Mark Wheater Interested Party Reference number: [REDACTED]-Resident of Thorpe on the Hill, Written Statement

Discussed at Issue Specific Meeting 1on Wednesday 7th January re Agenda item 3.2
Alternatives to the Proposed Development

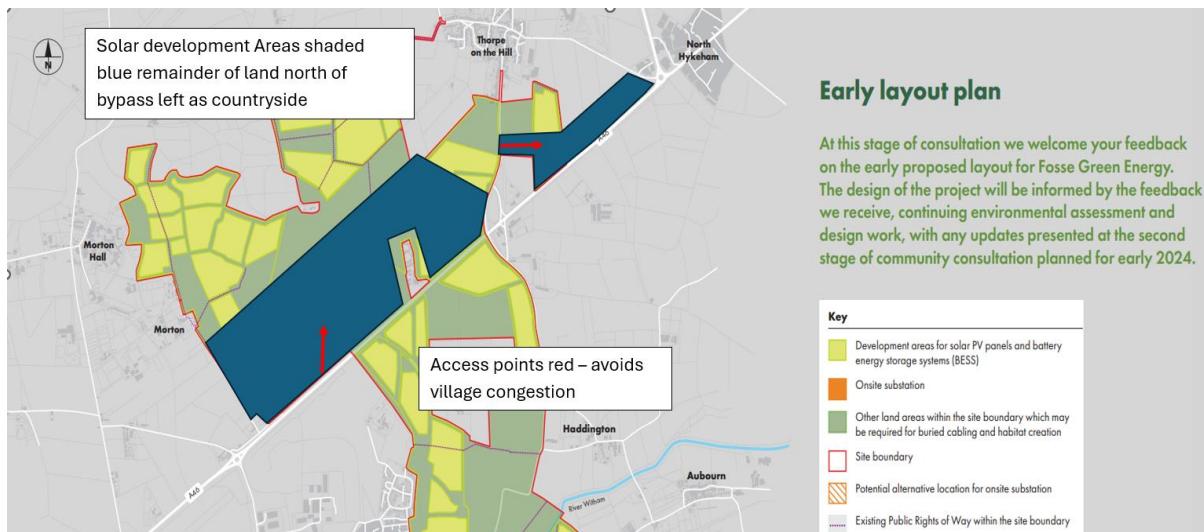
An alternative scheme was proposed in APP-029 Environmental Statement, section 4.9 Alternatives Proposed at Statutory Consultation. The proposed scheme is shown below(The area blue was marked on the developer's proposed plan to show the difference as clearly as possible):

The applicant rejected the proposal on four grounds however, I respectfully do not agree with the developer's reasons for rejecting the alternative site. I have set out the reasons for this below:-

1 The area would result in a reduction of 175MW to 130MW. This reduction can be made up elsewhere within the wider DCO site away from residential houses and be made up from the overplanting ratio of 1.59.

2) The alternative layout does not align with the design vision which is to maximise renewable energy generation across the site. This in my view isn't a design vision in accordance with good design principles in the NPS. A design vision would be to deliver a sustainable scheme which fits into local landscape and is integrated with the local community and which can be valued by all.

3) Some of the solar development area (small area) is outside the DCO and therefore could not be delivered. At the time of consultation, the boundary should not have been finalised before representations were considered and CPO powers exist to secure additional land, therefore this should not have been a reason to reject the proposal. The area concerned is only a small section of land when compared to the wider site.

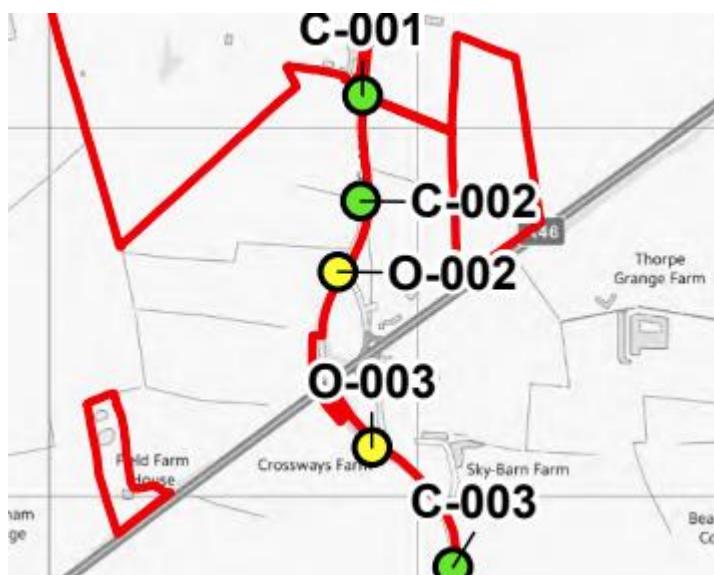
4) Access from A46. The principle in the alternative scheme was to avoid traffic coming through the village and this could be achieved on the same basis as the applicant's latest scheme and therefore doesn't need to be on the A46 as shown in my alternative design but, could use the access points proposed by the applicant in this application (AS-025 Site Access Location Plan Rev 2 Operational access 0-002) See plan below. My plan would therefore need to be amended to reflect this.

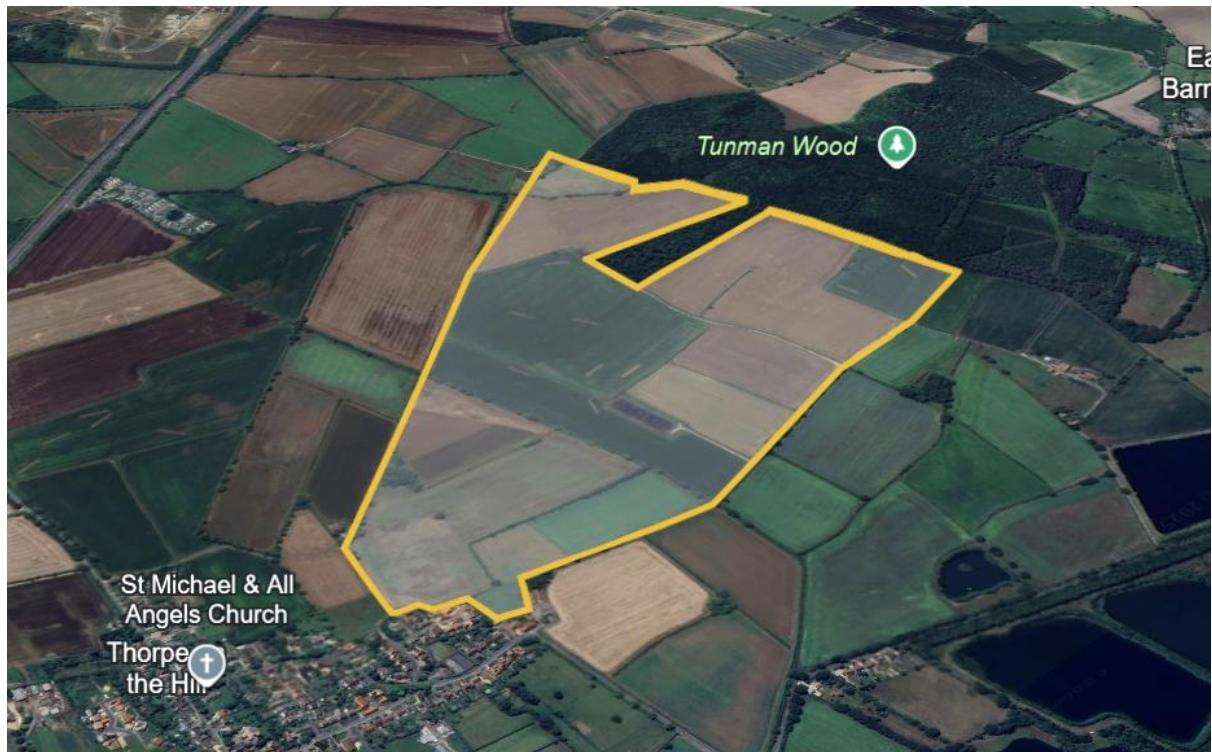
In my view the revised scheme mitigated many of the significant adverse impacts generated by the huge scale of the current scheme and provided Thorpe on the Hill with some protection against an industrialised landscape and protection for the Ancient Woodland- Tunman Wood.

The land edged yellow where it is proposed to install a significant number of solar panels under the applicants scheme is particularly sensitive, as this is the amenity land for the village/wider residents walking to the Ancient Woodland and for key views around Thorpe on the Hill. If Solar panels could be avoided on this area as shown on my proposed scheme, significant adverse effects would be mitigated and quality amenity and landscape maintained.
